Gartex Garments Ltd.

1731, Mostofa Hakim College Road, Cornel Hat, North Kattali, Pahartali, Chittagong.
(22.372642N, 91.769580E)

17th May 2014

**High stress levels
in some columns**

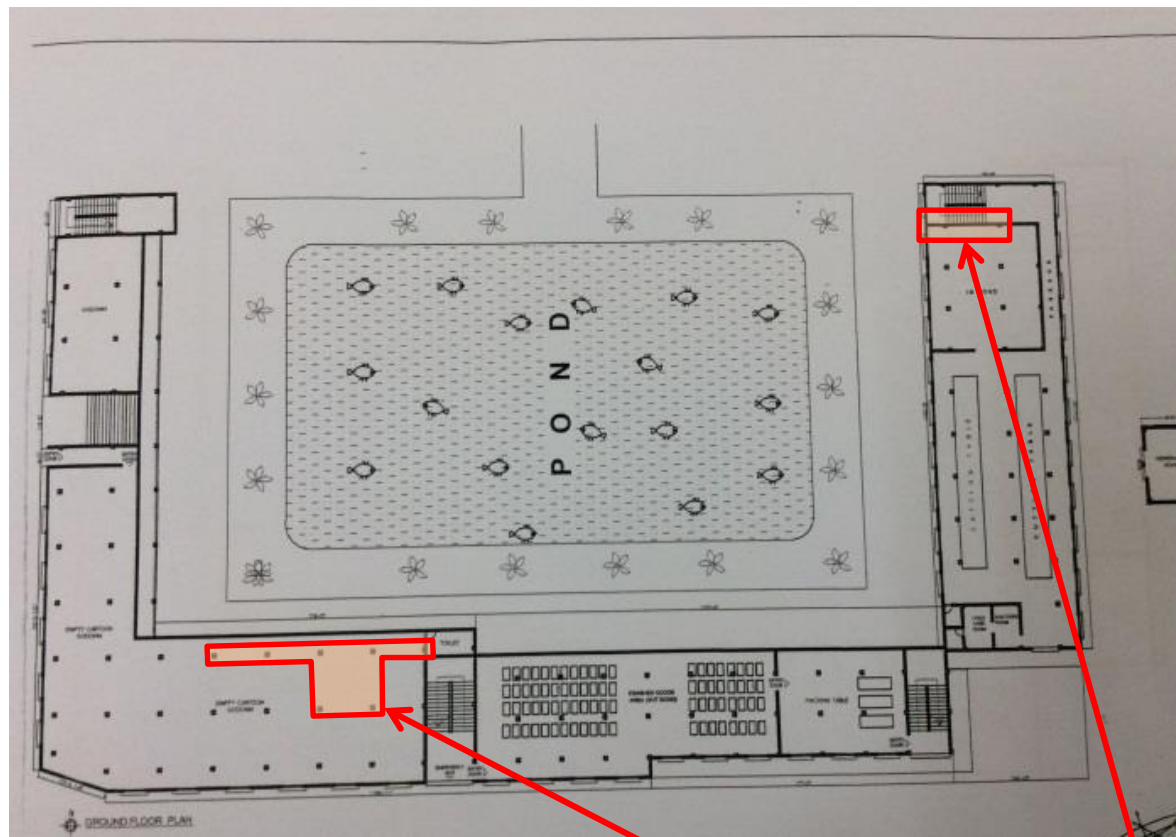
Stress levels were calculated to be high in specific areas within the building.

High stress levels in these locations

Item No.	Observation	Recommended Action Plan	Recommended Timeline
1	Stress levels in Columns	Building Engineer to review design, loads and stresses in columns in the area noted.	6-weeks
2	Stress levels in Columns	Building Engineer to verify insitu concrete strength by taking 100mm diameter cores from 4 columns.	6-weeks
3	Stress levels in Columns	Building Engineer to verify grade of steel reinforcement and no. and diameter of main column bars.	6-weeks
4	Stress levels in Columns	Make structural alterations if required as advised by Engineer.	6-months
5	Hairline cracking on beams and some slab soffit areas	Monitor cracks on beams. Building Engineer to investigate if cracks are only in the plastering.	6-months
6	Hairline cracking on beams and some slab soffit areas	Building Engineer to advise on load reduction and repair and strengthening if required.	6-months
7	High Loading due to Water Tanks and toilets	Building engineer to check the capacity of the slab to carry the concentrated loading and remove/reduce the loading	6-weeks

Localised high loading on floors

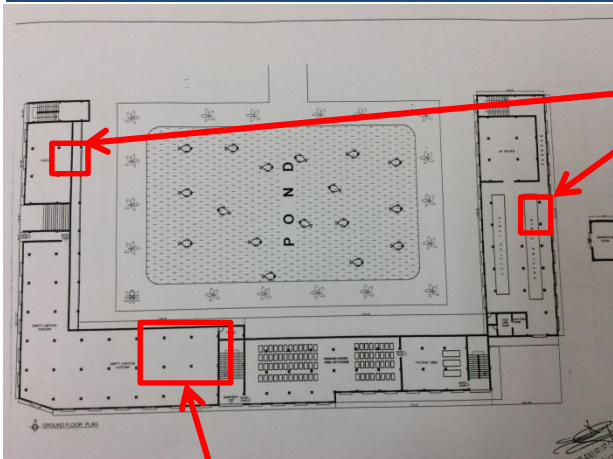
Various areas across the building see significantly increased loadings relative to the typical factory-floor loads – most notably this can be seen beneath the water tank, which is elevated on a concrete stand above the roof level and 2 tanks placed on the roof slab.

Water Tanks
on roof slab

Concrete stand for water tank above

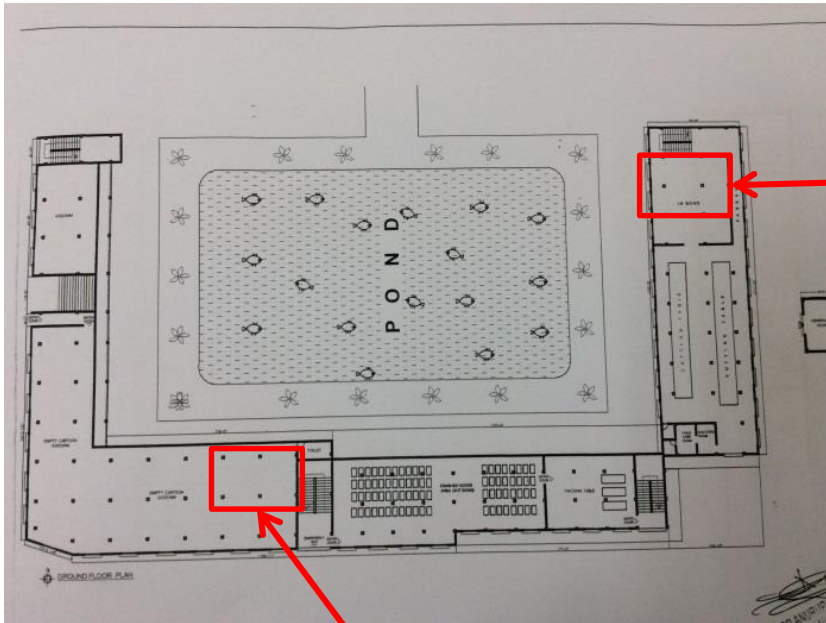
Area in which water tank loading (roof level) and concrete build-up for toilets (Level 2 and Roof) are situated.

Storage below

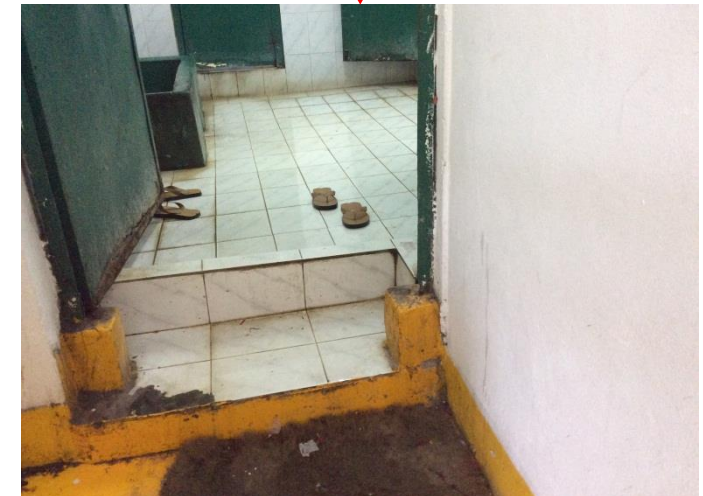
Toilet areas, which contain masonry partitions and significant build-up at floor level, are inflicting significantly higher loads in certain locations.

Toilet area situated next to masonry wall for staircase, resulting in increased loads on Levels 1 & 2

Typical build-up arrangement

Area in which water tank loading (roof level) and concrete build-up for toilets (Level 2 and Roof) are situated.

Hairline cracking on beams and slabs

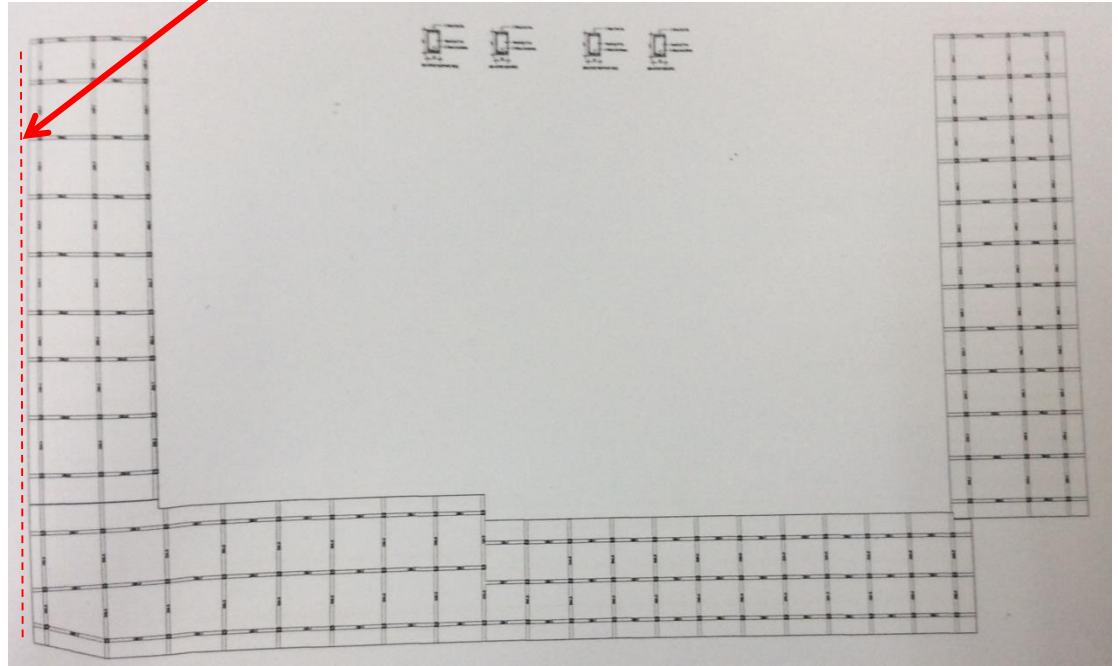
Vertical cracks (possibly resulting from thermal effects) appear in a significant number of beams, although the majority have been painted over. These occur more frequently at higher levels than lower down the building.

A small number of cracks were found in slabs. This crack was observed on the ceiling of Level 2, directly beneath the Roof Level Toilets, which were actually used as storage space.

Discrepancies between drawings and site observations

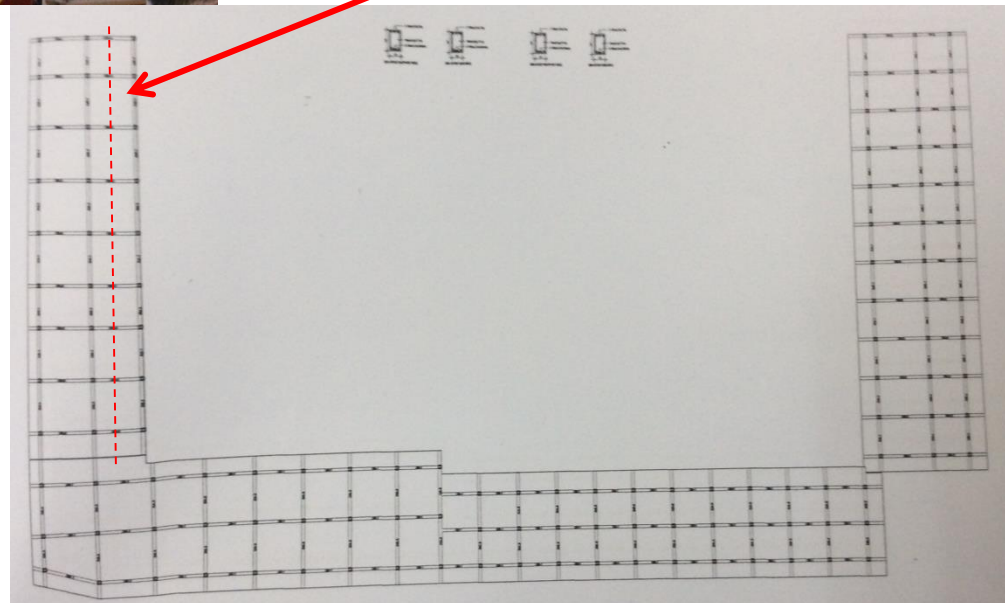
Rendered brick columns have been constructed beneath cantilevers at ground level on this line.

Beams are discontinued at the line indicated here on Level 1 and 2, indicating that the building may originally have been constructed to this line.

8	Differences between actual construction and information on design drawings	Building Engineer to survey the structure and prepare a full set of “as-constructed” drawings.	6-months
9	Steel roof connections to columns appear non-engineered	Building Engineer to check the capacity of the lightweight roofs and make any necessary alterations.	6-months
